From: [John Schmuck](#)
To: [Lancaster, Thomas](#)
Subject: FW: Marsland RAI Responses - RAI 12.A, 37.A.1, 37.C, Admin Section 5 #3 and #4 Email 1a of 3
Date: Monday, July 14, 2014 3:07:36 PM
Attachments: [NRC TR RAI Additional Responses Radiological Subject Matter 7-11-2014 Status.pdf](#)
[Marsland TR Section 2 Air Station Locations 7-11-2014.pdf](#)
[TR Figure 2 9-2 reprint \(2\).pdf](#)
[Marsland TR Section 5 RWP Designee redline 7-11-2014.pdf](#)
[Marsland TR Section 7 Mildos redlines 7-11-2014.pdf](#)
[Table 7 3-2 Public and Occupational Doses 7-11-2014.pdf](#)
[TR Figure 7 3-2 MILDOS Receptors - Residences and Designated MEA License Boundary Locations 11x17 07022014 reprint \(2\).pdf](#)

From: John Schmuck
Sent: Monday, July 14, 2014 12:10 PM
To: Lancaster, Thomas (Thomas.Lancaster@nrc.gov)
Cc: Rhonda Grantham; Doug Pavlick; Larry Teahon; Sabrina Fox; Larry McGonagle
Subject: Marsland RAI Responses - RAI 12.A, 37.A.1, 37.C, Admin Section 5 #3 and #4 Email 1 of

Cameco Resources Responses to NRC Marsland Technical Report RAIs – Radiological Subject Matter July 11, 2014 Status/Clarifications

**FIGURE 2.9-2
LOCATION OF ENVIRONMENTAL AIR
SAMPLING STATIONS AT MARSLAND
EXPANSION AREA**

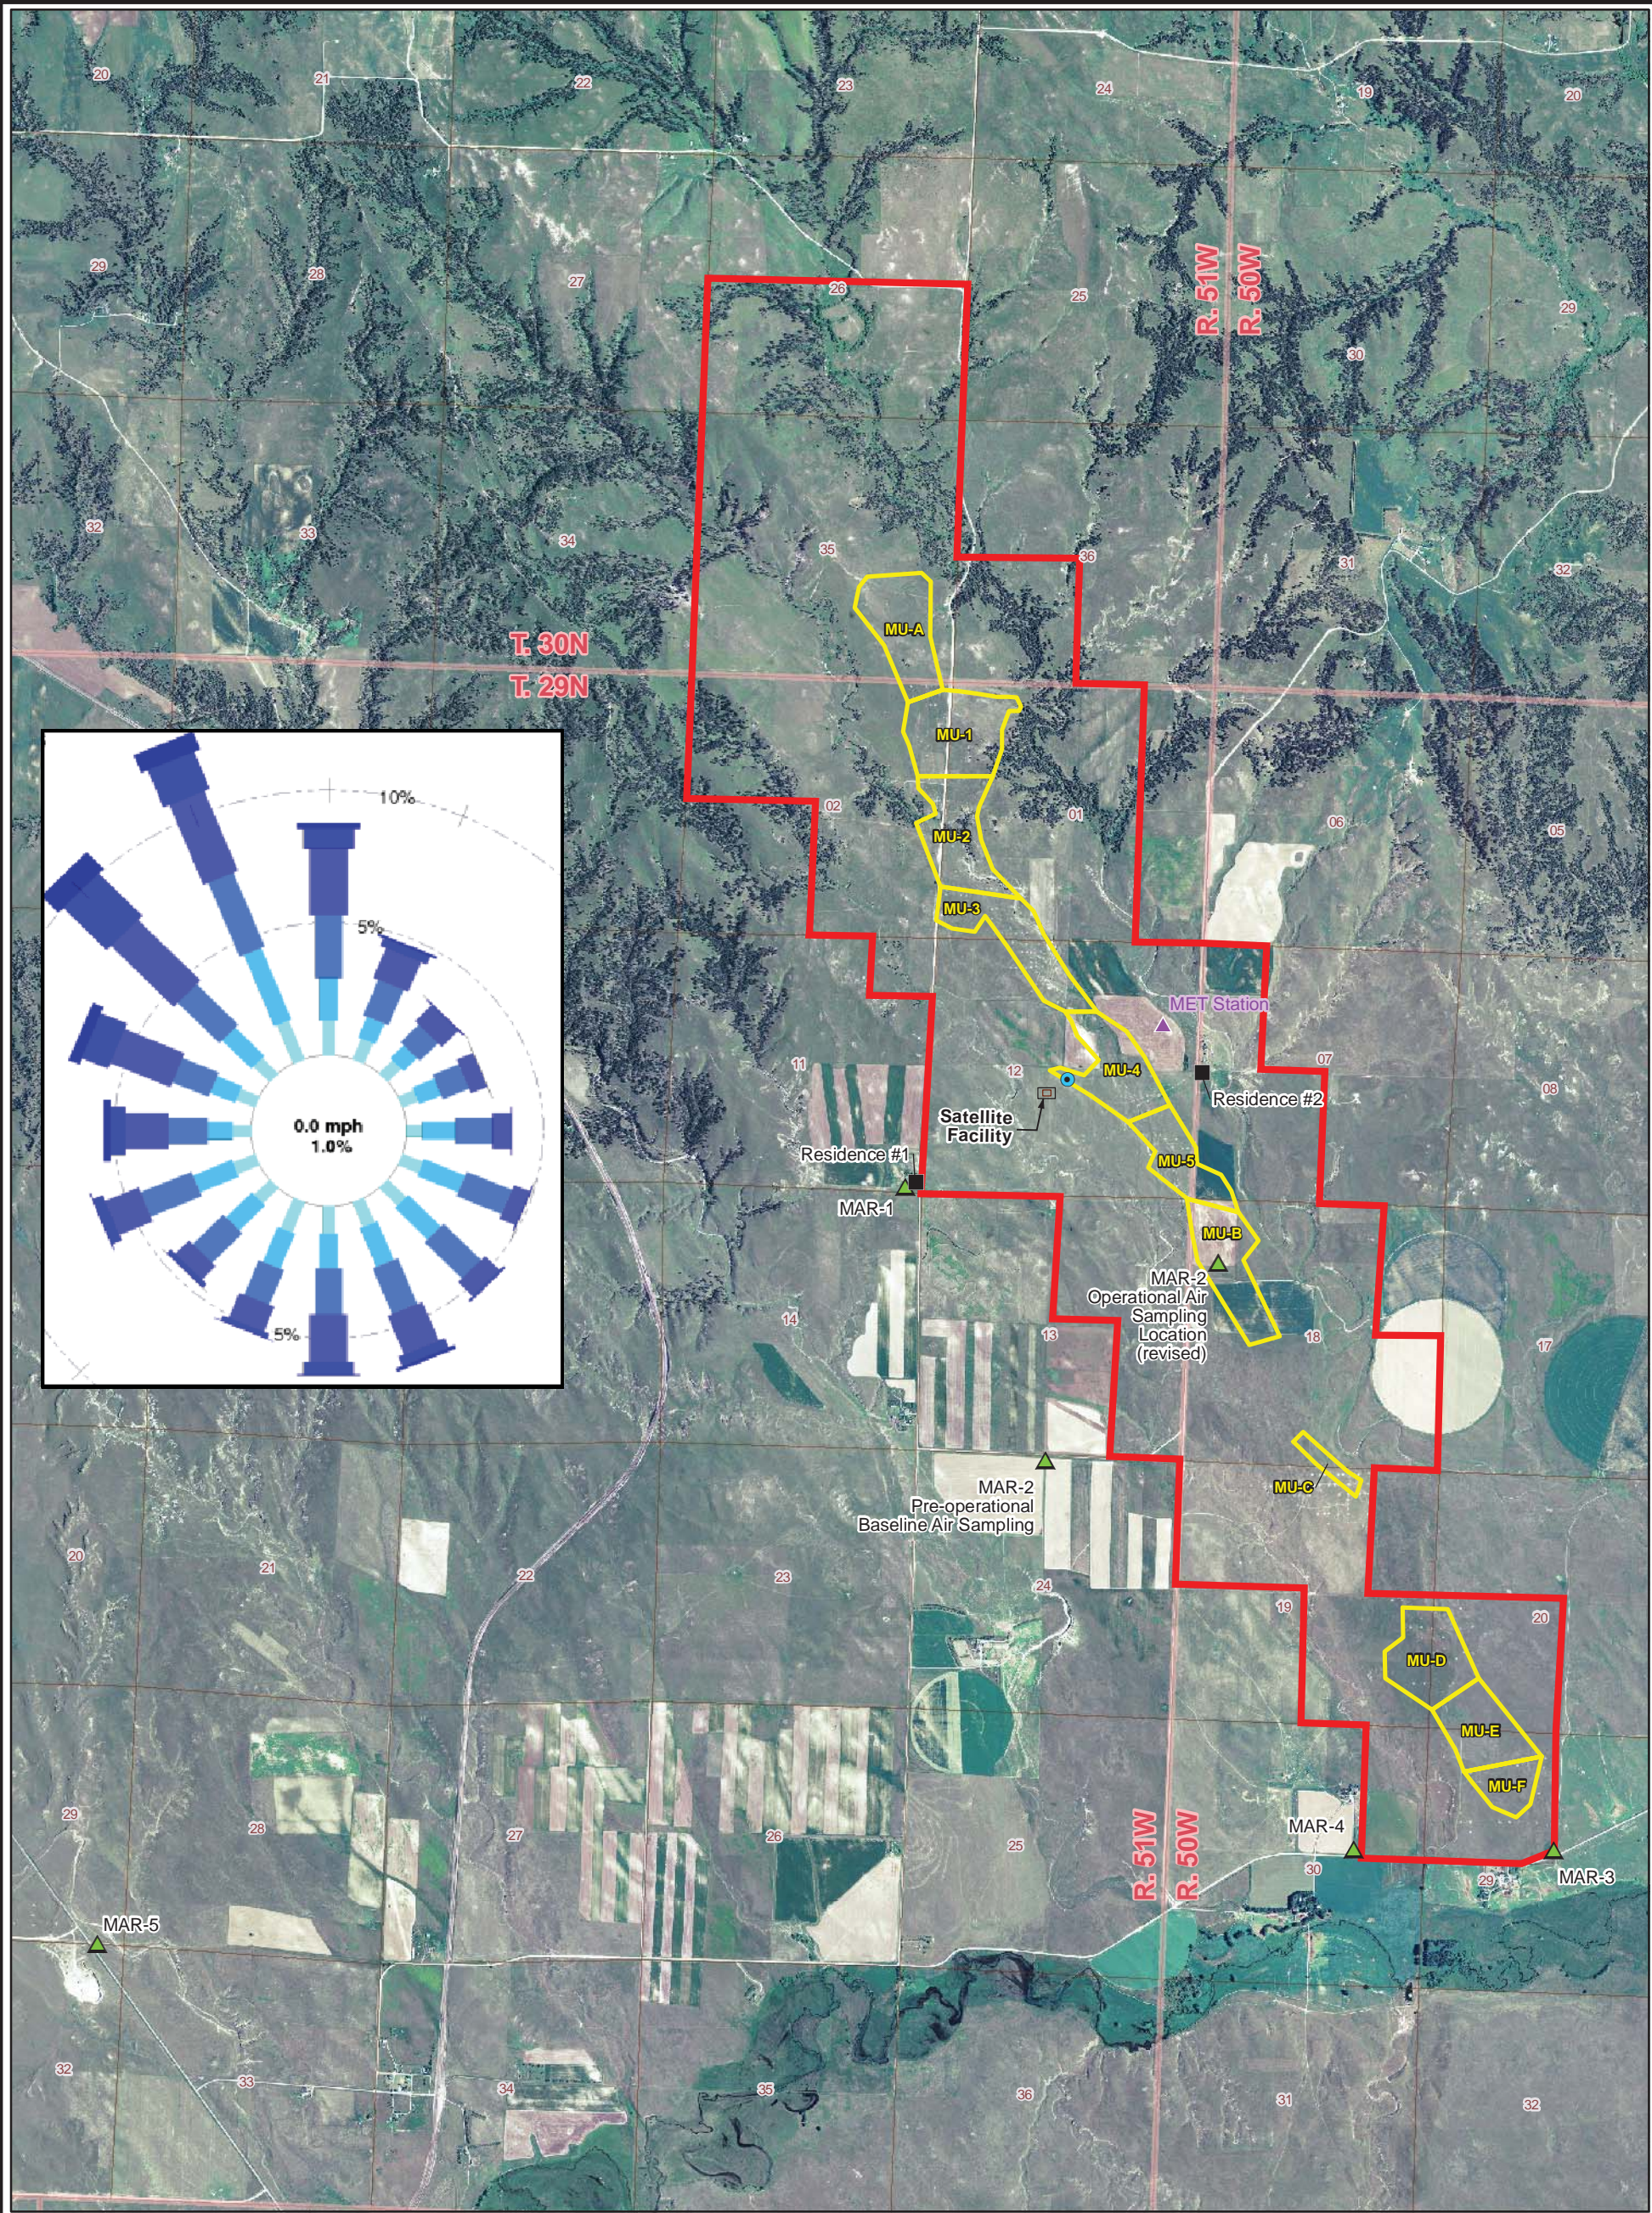
During baseline monitoring, Site MAR-2 was located directly south of the proposed mill, and slightly outside the project boundary. For operational monitoring Site MAR-2 is being relocated, as described below. Sites MAR-3 and MAR-4 on the southernmost boundary of the project represent prominent downwind locations. The on-site wind rose shows north-northwesterly, northwesterly, and northerly winds to be the most frequent, accounting for more than 25 percent of the time. Hence, these three monitoring sites are located south-southeast, southeast and south of the proposed milling operation. The wind roses are shown in **Figures 2.5-20 and 2.5-21**.

Following completion of preoperational baseline monitoring, the Mildos Area assessment was significantly refined. Those revisions are now included as part of Section 7. The location of estimated maximum contaminant concentrations due to dose associated with radon progeny is located approximately 1.5 km southeast of the Sattellite Plant (see **Figure 5** in Appendix M). To

In accordance with these criteria, **Figure 2.9-2** shows three sampling sites at the project boundary (Sites MAR-1, MAR-4 and MAR-3). One of these (Site MAR-1) also coincides with the nearest, and most likely to be impacted, occupiable structure. A fourth sampling site (Site MAR-5) is intended to represent background conditions. Because the on-site wind rose indicates northeasterly winds to be the least frequent, this background monitoring site is located southwest of the project boundary at a distance of approximately 4 miles (6.4 km). A summary of monitor locations and elevations for each of the monitors is shown in **Table 2.9-1**.

satisfy RG 4.14, for operational air monitoring air monitoring station MAR-2 will be relocated according to criteria 5, noted above.

**FIGURE 7.3-2
MILDOS RECEPTORS
RESIDENCES AND DESIGNATED MEA
LICENSE BOUNDARY LOCATIONS**

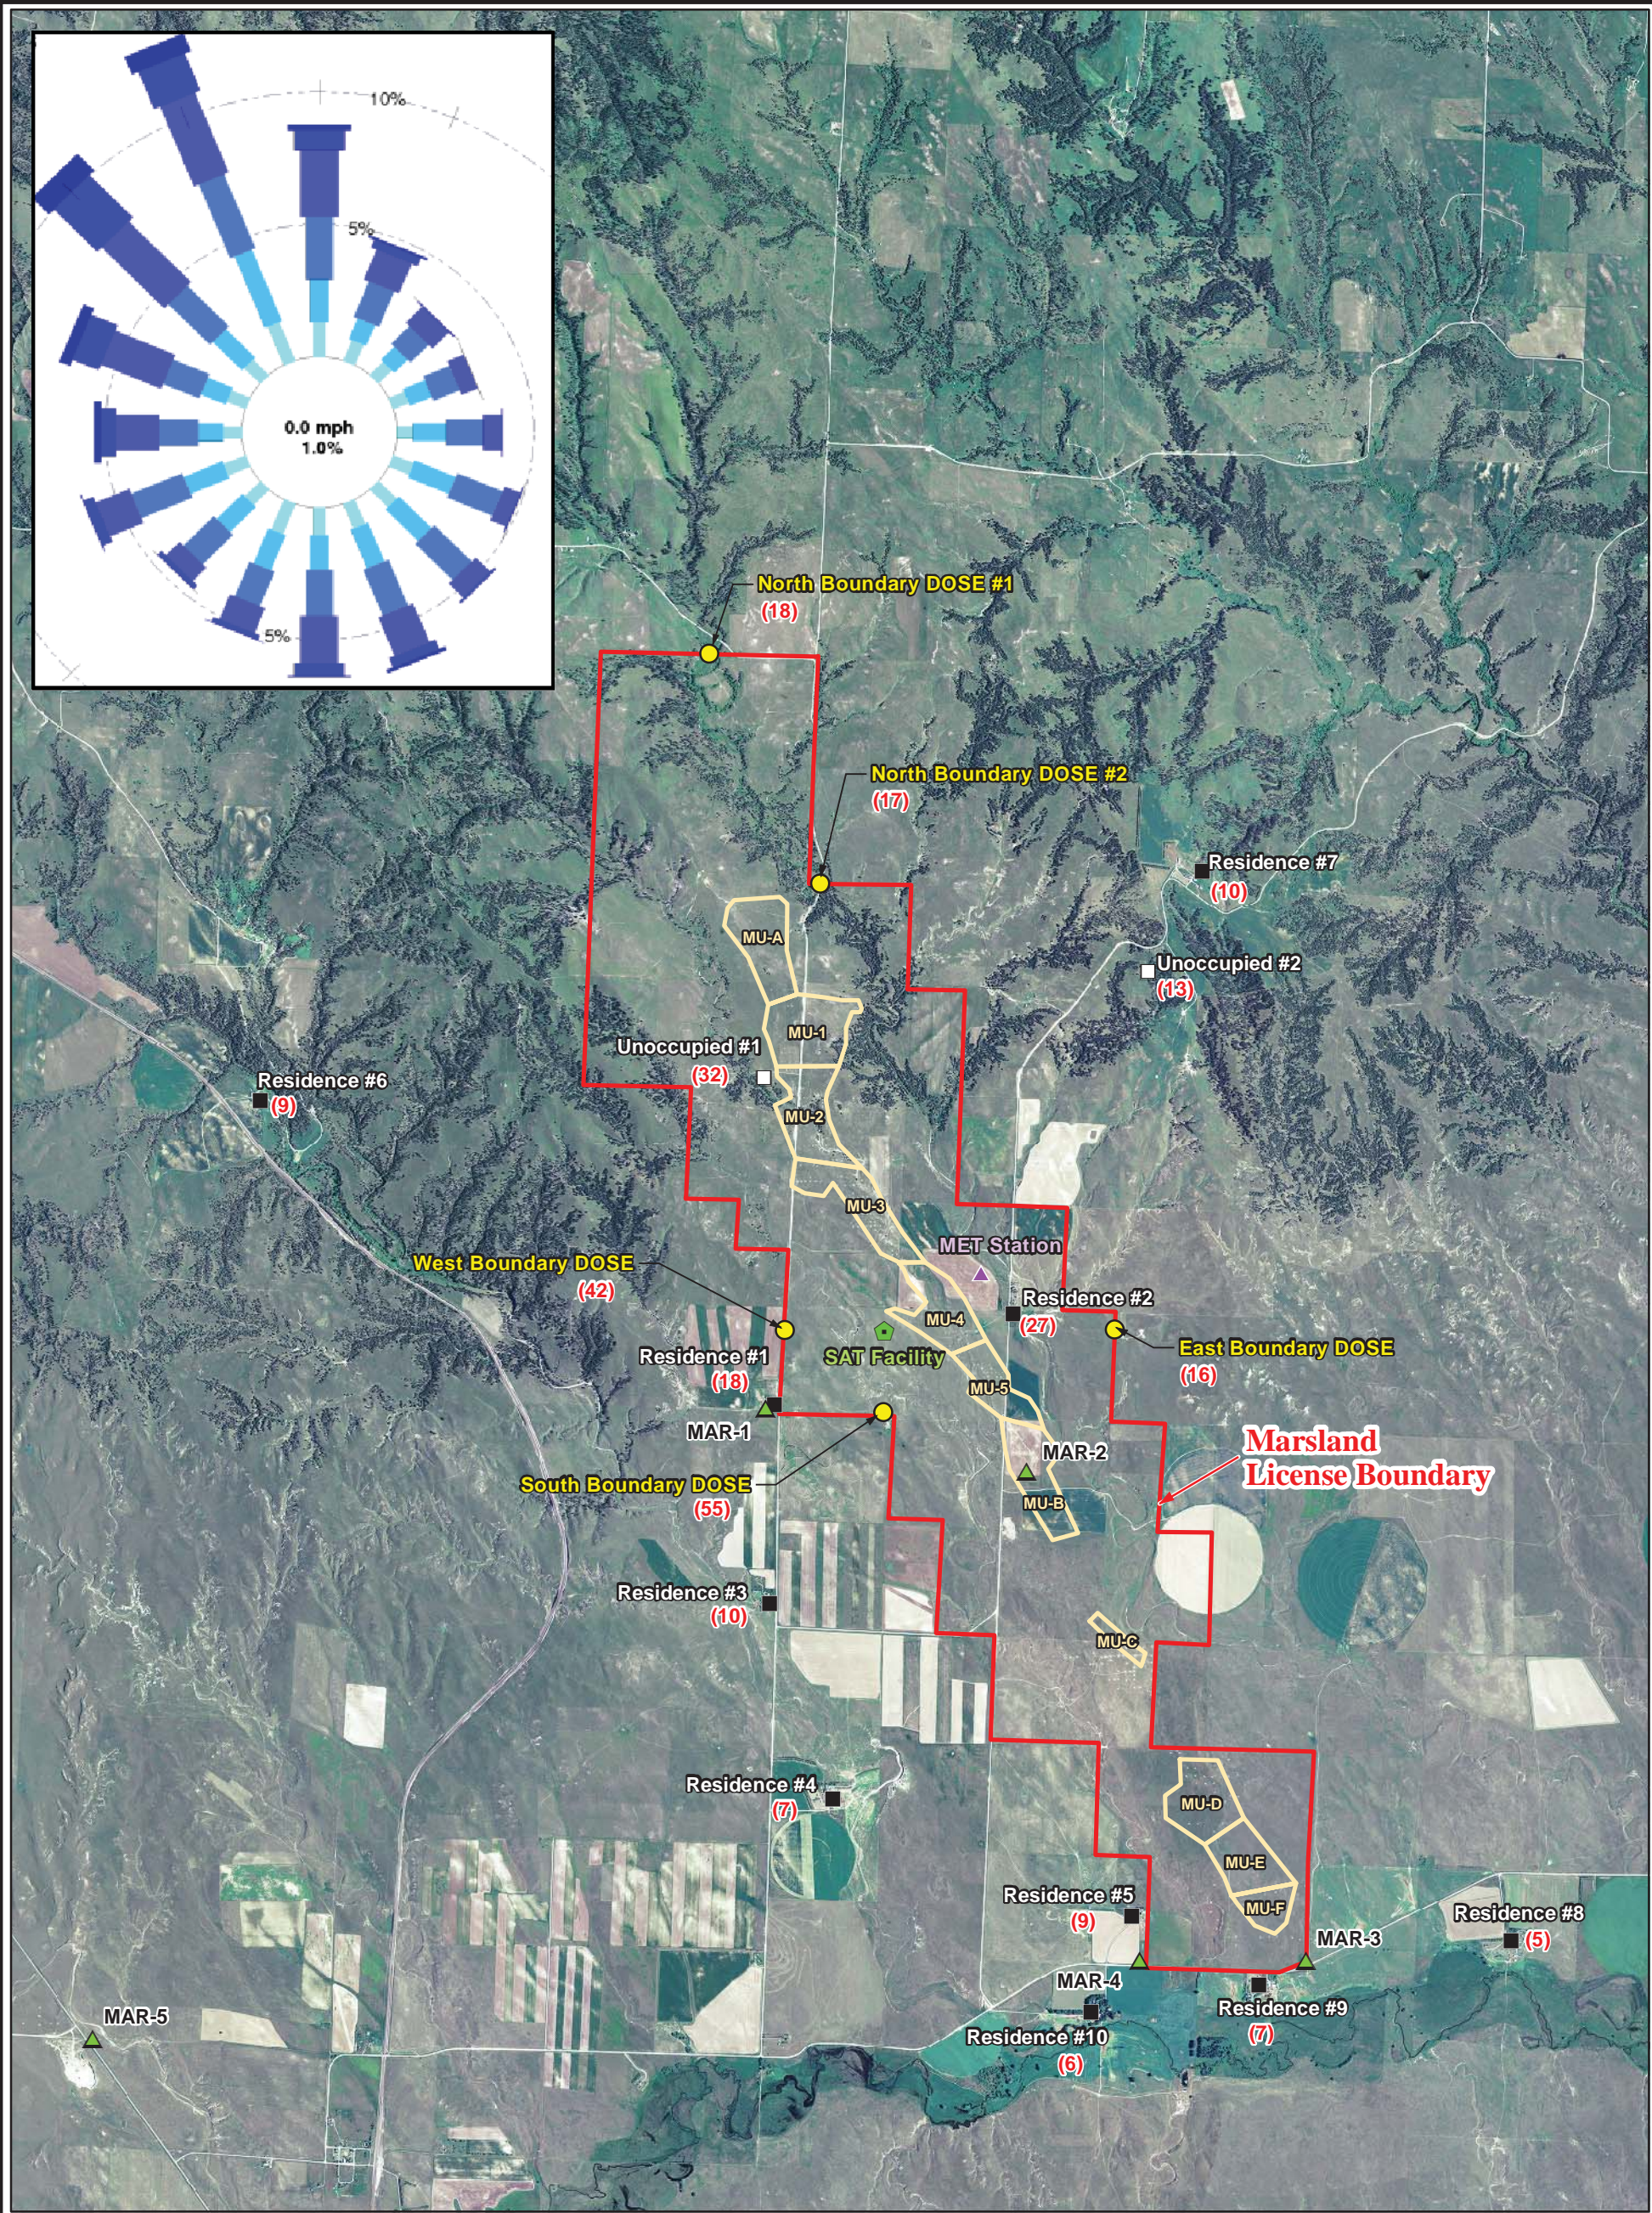
<p>RAI 8.C.2. TR Figures 2.5-30 and 2.5-31 provide a statistical analysis of the 15-yr and baseline-year wind speed and wind direction for the Scottsbluff meteorological station. Please provide the following information on these analyses:</p> <p>2. p-values for the linear regression equations presented in TR Figures 2.5-30 and 2.5-31.</p>	<p>Cameco 12/23/2014 Response: No response required. In the public meeting dated September 4, 2013, NRC stated the RAI had been resolved by the revisions submitted by Cameco on June 26, 2013. This was confirmed in the NRC letter dated October 23, 2013.</p> <p>Cameco 5/27/2014 Status: No update.</p> <p>Cameco 7/11/2014 Status: No update.</p>
<p>RAI 12.A <u>Description of Deficiency</u> Staff can't complete its evaluation of NUREG-1569, Acceptance Criterion 2.9.3(1).</p> <p><u>Basis for Request</u> 10 CFR Part 40, Appendix A, Criterion 7, requires: "At least one full year prior to any major site construction, a preoperational monitoring program must be conducted to provide complete baseline data on a milling site and its environs. Throughout the construction and operating phases of the mill, an operational monitoring program must be conducted to measure or evaluate compliance with applicable standards and regulations; to evaluate performance of control systems and procedures; to evaluate environmental impacts of operation; and to detect</p>	<p>Cameco 12/23/2014 Response: In the public meeting dated September 4, 2013, NRC requested additional siting justification for the air monitors, specifically, consideration of where maximum concentrations are expected. To that end, in addition to the revisions to Section 2.9.2.1 submitted by Cameco on June 26, 2013, further siting justification is provided in Section 2.9.2.1 as well as revisions to Figure 7.3.2 depicting the locations and the estimated doses.</p>

- Deleted: 3
- Deleted: 2.2
- Deleted: North Boundary #2
- Deleted: 5
- Deleted: 3.8
- Deleted: 21
- Deleted: 14.8
- Deleted: 15
- Deleted: 11.0
- Deleted: --
- Deleted: 25.9
- Deleted: --
- Deleted: 42.6
- Deleted: --
- Deleted: 32.3
- Deleted: --
- Deleted: 36.8
- Deleted: --
- Deleted: 25.8
- Deleted: 43
- Deleted: 31.3
- Deleted: 20.9
